**PLAN COMMISSION / ZONING BOARD OF APPEALS  
AGENDA**

**Project:** Sparks Coffee Co. – New Construction  
**Meeting Type:** Public Hearing  
**Request:** Major change to PUD, Special Use Permits (4)  
**Location:** Hickory Creek Marketplace, Outlot 1E  
**Applicant:** Aliana Winkle  
**Prop. Owner:** Winkle R E Properties  
**Representative:** Applicant  
**Staff report by:** Christopher Gruba, Senior Planner

## **Major changes to plans since workshop**

A101

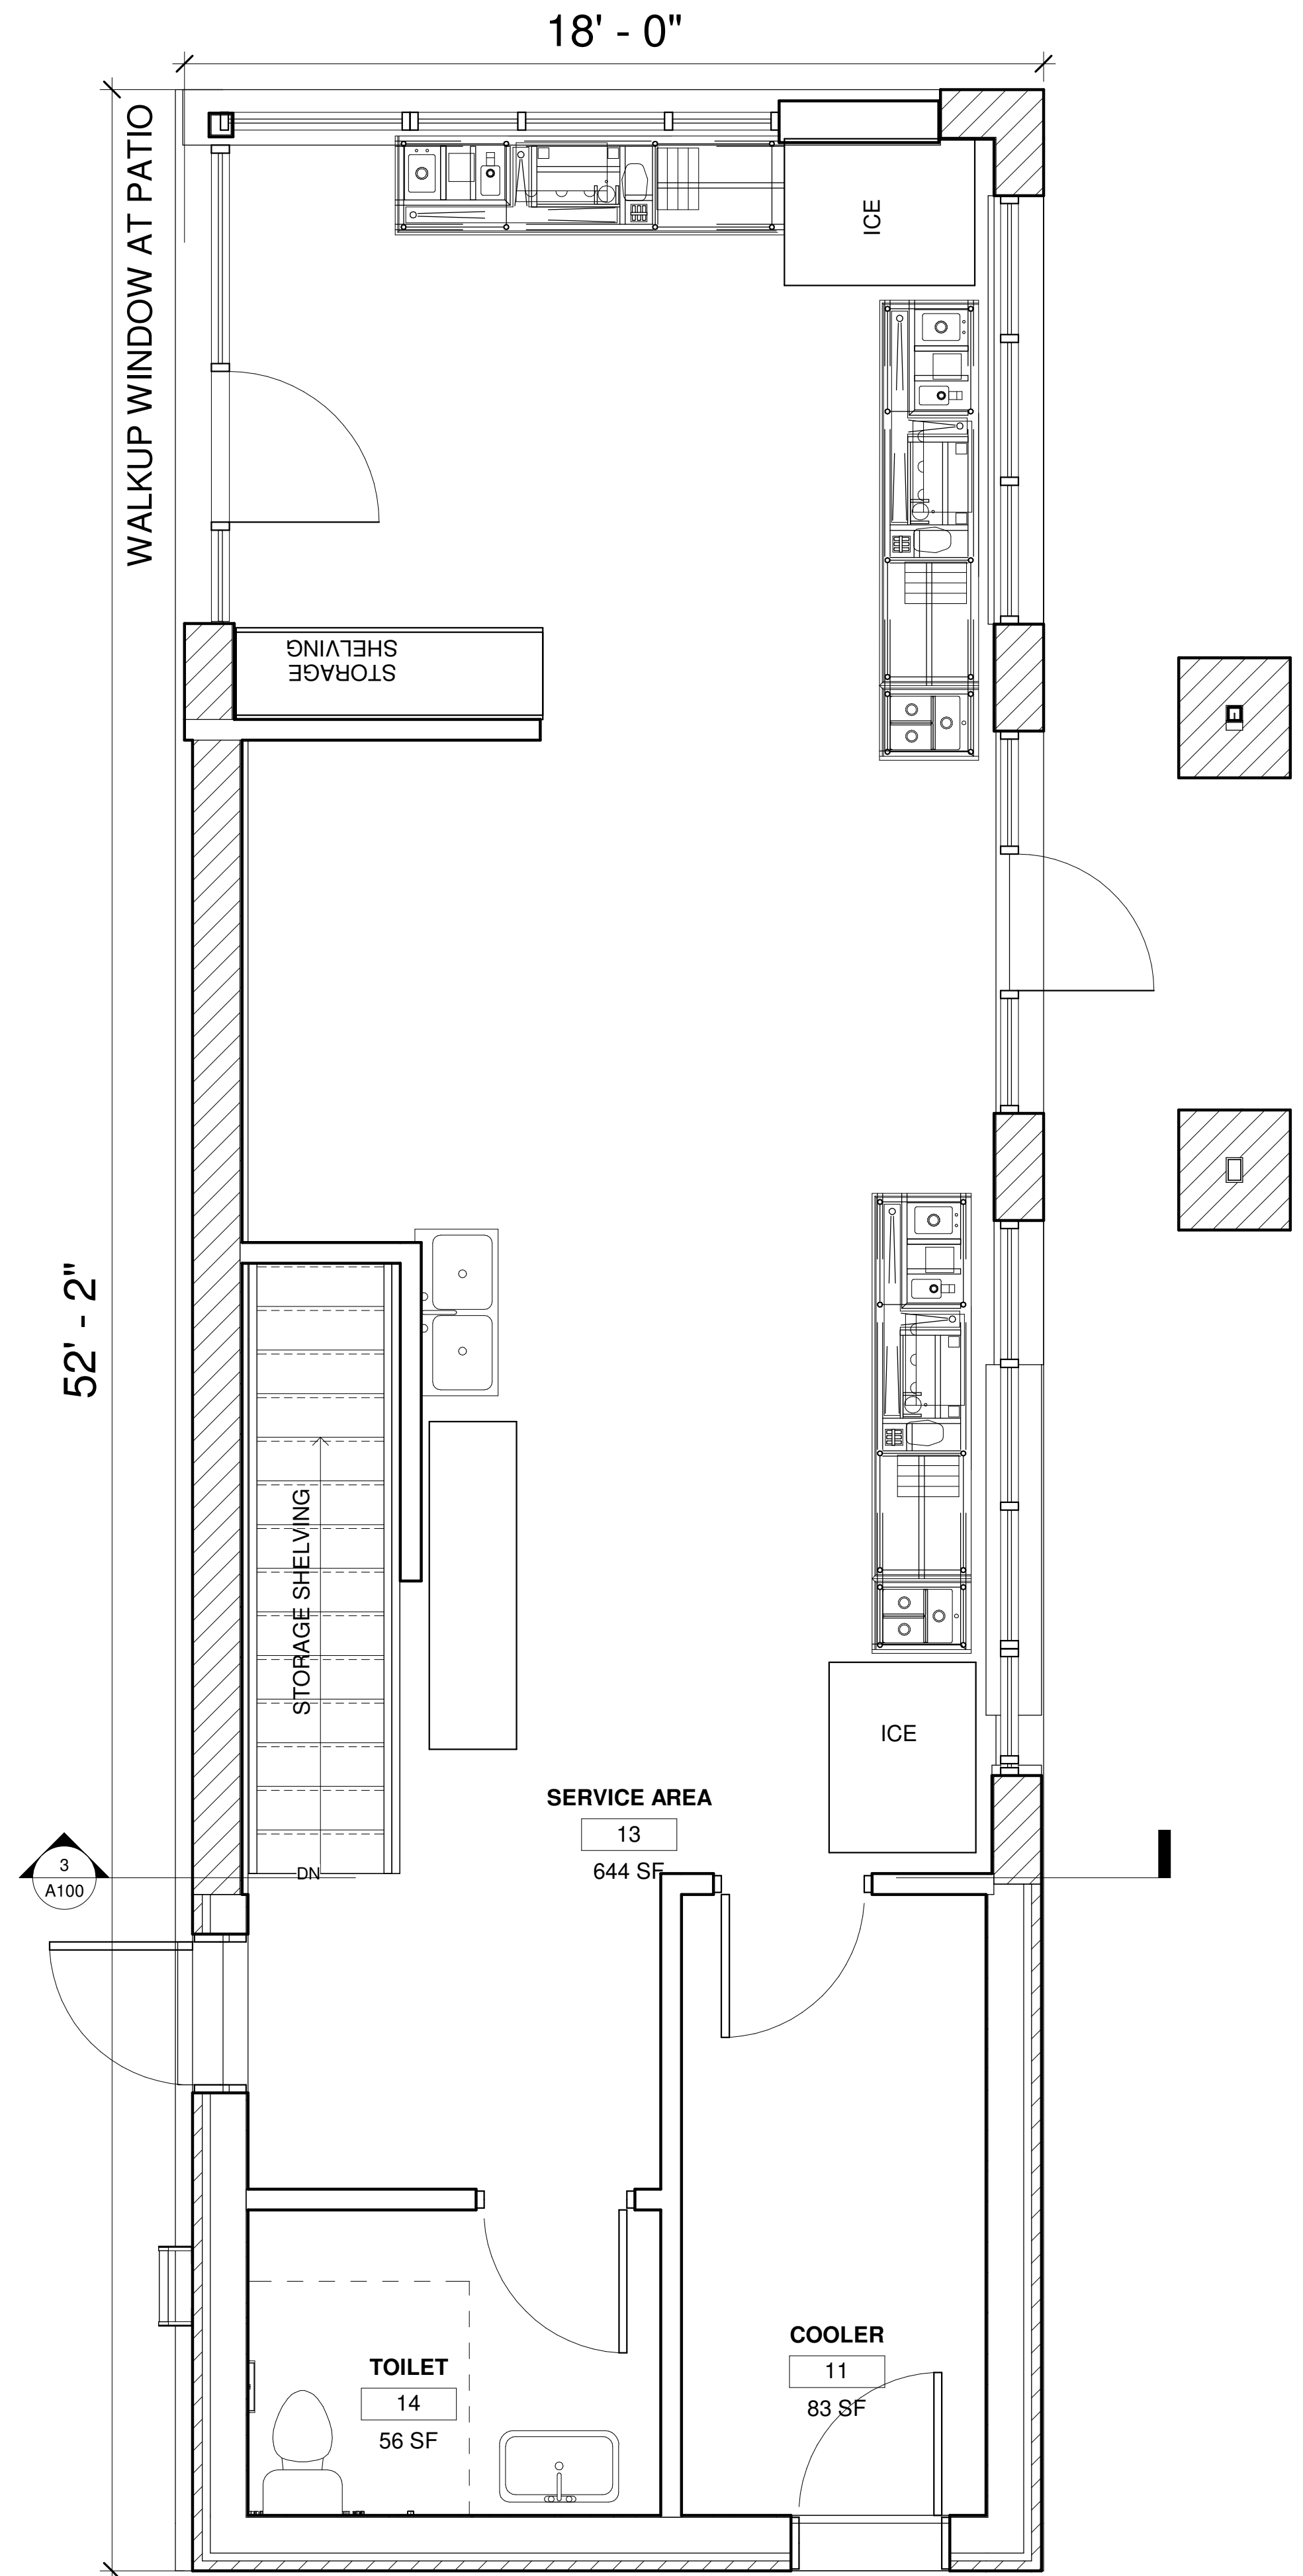
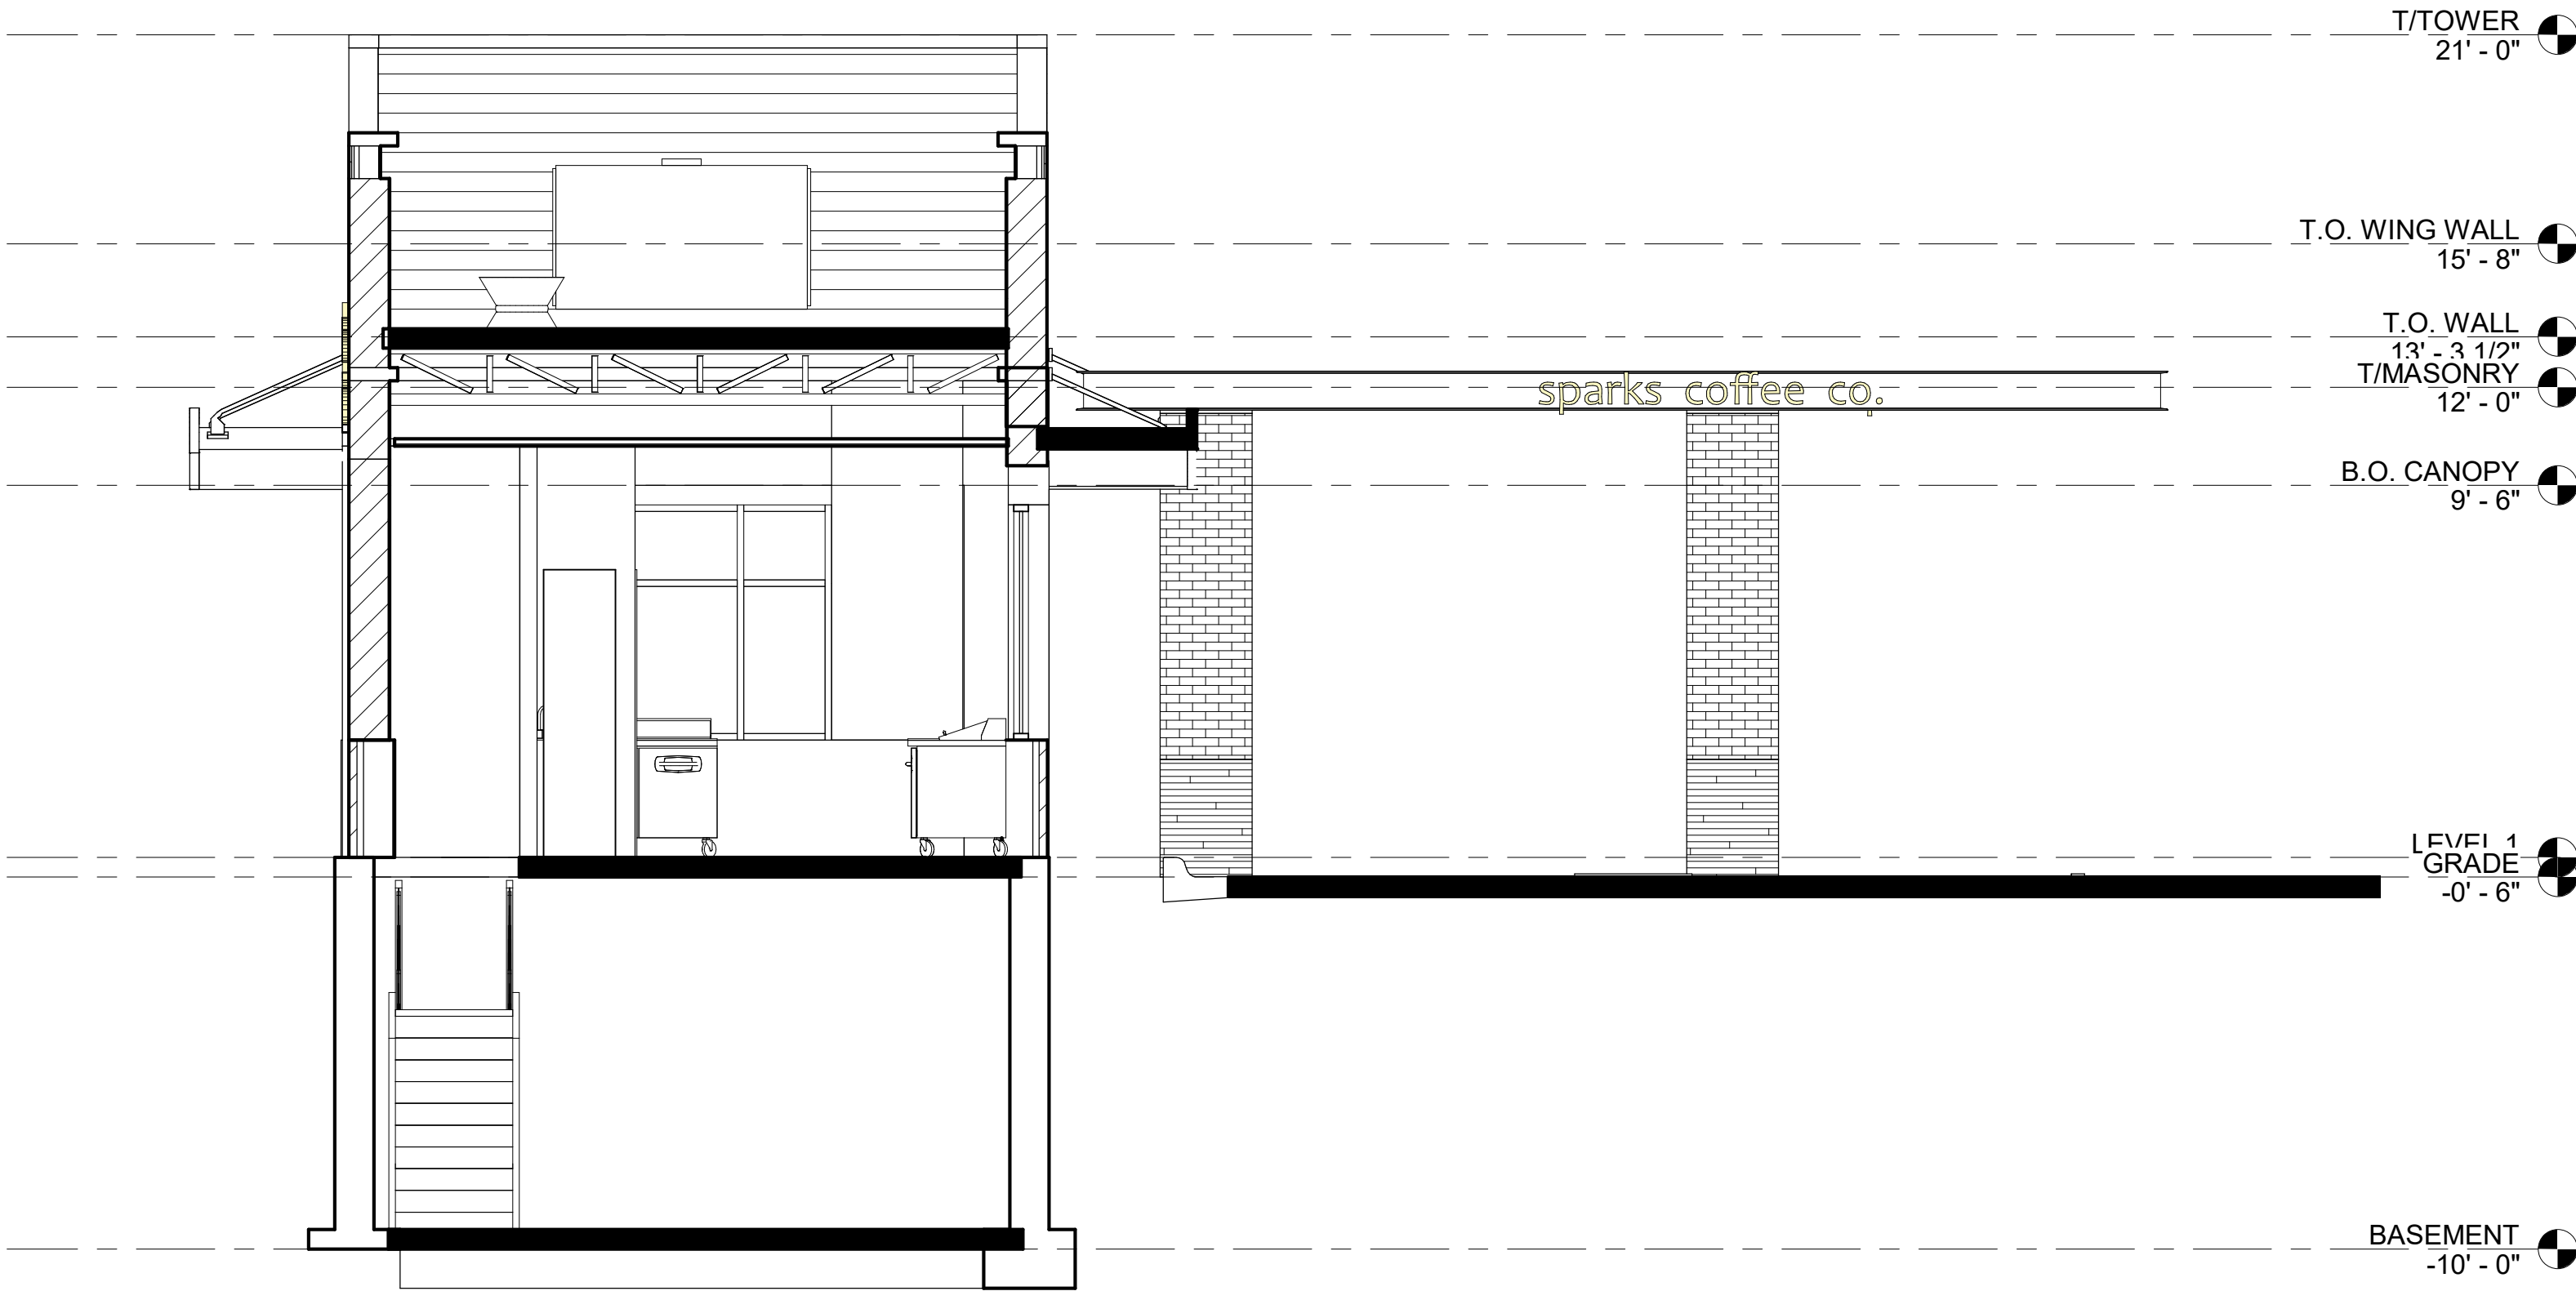
4. A full basement is proposed as illustrated on Sheet A101. Although not defined on the floorplan, it was stated by the applicant at the workshop meeting that the basement will be used for storage.
